Golden Highway Upgrade at Winery Hill

Review of environmental factors consistency review 2 – additional landscape feature

Roads and Maritime Services | November 2019

Figure 1 – Additional construction area

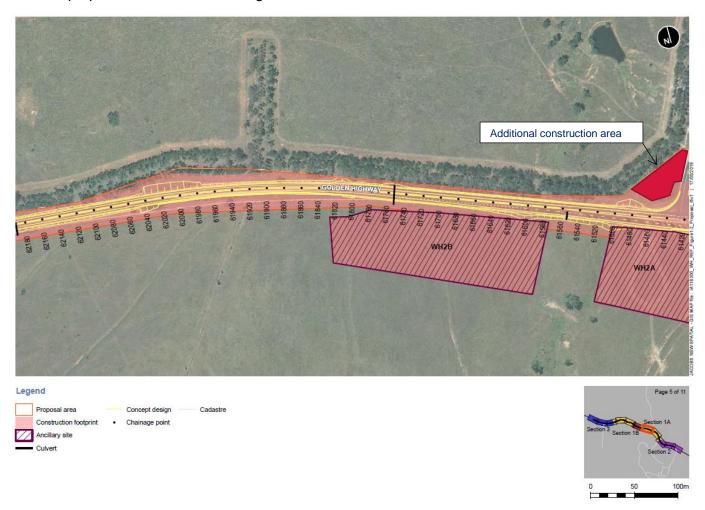
The proposed modification includes the provision of an additional construction area for development of a permanent landscape feature.

The proposed additional construction area is approximately 40 metres long by up to 40 metres wide. The proposed additional construction area is located within the Golden Highway road corridor, on the western side of Edderton Road.

The additional construction area is located adjacent to the existing construction footprint and wholly within the REF proposal area as shown in Figure 1.

Selected earthworks materials (approximately 2,000 tonnes) that conform to the EPA's Excavated Public Road Material waste (EPRM) exemption would be reused on site in the creation of a beneficial landscape feature by widening and flattening the road batters adjacent to the Golden Highway instead of being disposed off-site.

- Despite provisions of the EPRM waste exemption, the landscape feature would not be used for the placement of steel, blast slag, bitumen, reclaimed asphalt pavement, gravel, slag from iron and steel manufacturing, fly and bottom ash, brick, concrete, ceramics etc, that can otherwise be recycled off-site at approved recycling facilities
- Implement all applicable safeguard, management measures and procedures contained within the approved CEMP and management sub plans to avoid encroachment and/or direct/indirect impacts beyond the approved project boundary
